Staff Report & Recommendation

Design Review Board

SUBJECT: DRB18-0333
5500 Collins Avenue – Towerhouse Condominium

DRB18-0333, 5500 Collins Avenue. The applicant, Towerhouse Condominium, Inc., is requesting Design Review Approval to replace the existing precast baluster railings system along the balconies of the west (Indian Creek), north and south and west elevations of the existing 25-story building with all clear glass railings.

Details of typical floor plan from original plans, Permit 88131

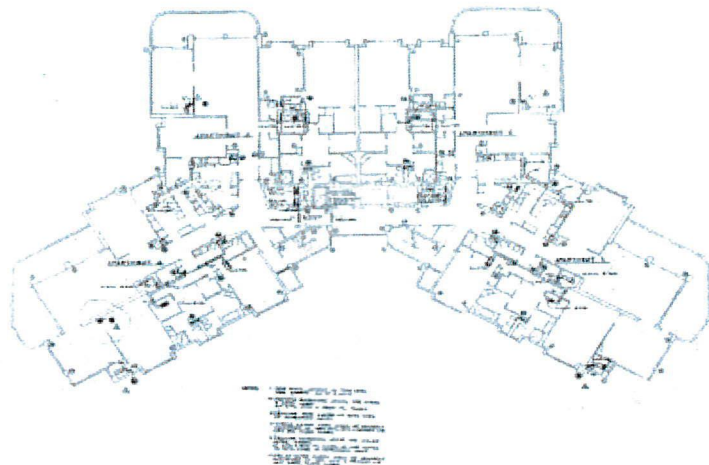
The original design for the Reiff-Fellman building contained precast concrete balusters with a tapered fin design that reflect the shape of the building. The pre-cast railings are a character defining element of the building's architecture. Nevertheless, the removal of the decorative concrete brise soleil and other solid masonry railing systems for the replacement of full glass railings along waterfront facing frontages has been proposed in the past.

The railing design proposed at the December 04, 2018 DRB meeting was a post-less glass balcony system that allowed for uniform views of the Indian Creek waterway and the northern and southern vistas of Collins Avenue. The original design of the building does not feature balconies directly facing the east, likely due to the existence of the expansive Castle Beach Condominium built in 1964 that broadsides Collins Avenue and effectively blocks all views of the ocean. The pre-cast concrete fin detail that adorns the existing balconies occurs mostly on the less visible elevations, the north, south and west, of the building. However, given that the rear portion of the balconies along the side elevations of the building are visible from the street, the Board requested that the applicant further investigate bringing into the new design of the railings some of the verticality provided by the pre-cast fin detail.

In addition to the original proposed design scheme, or "Option 1", that was presented at both the December 04, 2019 and the February 05, 2019 DRB meeting, the applicant is proposing another railing design based on the Board's comments. At both meetings, the Board recommended that the applicant explore incorporating into the glass railing design details that evoke the vertical articulation of the pre-cast fins. The first design scheme, "Option 1", maintains the originally proposed post-less impact, bronze glass railing system. The second scheme, or "Option 2", introduces posts, adorned with a metal fins, between glass panes along the entire length of the balcony system. The new scheme begins to address the Board's comments. Staff recommends that the design of the proposed "fin" resemble more closely the pre-cast fin common in the existing railings. Furthermore, staff is amenable to a hybrid of both design that incorporates railings with posts and fins along portions facing Collins Avenue – those segments of balconies facing due north, east and south - and transitions to a post-less railing system along the eastern face of the balconies. Staff is supportive of either instance in which the design includes a vertical gesture that evokes the previous pre-cast fins, especially along the portions of Collins Avenue where their absence is most felt; and is confident that further study and refinement will result in a successful design. The modifications to the project suggested herein can be readily addressed administratively, as indicated in the recommendation.

- a. On all the balconies, the plans submitted for Option 2, a combination of glass and railings with the introduction of the "fin", shall be permitted with

- . further refinement of the proposed “fin” to more closely resemble the pre-cast fin common in the existing railings, in a manner to be reviewed and approved by staff consistent with the Design Review Criteria and/or the directions from the Board.
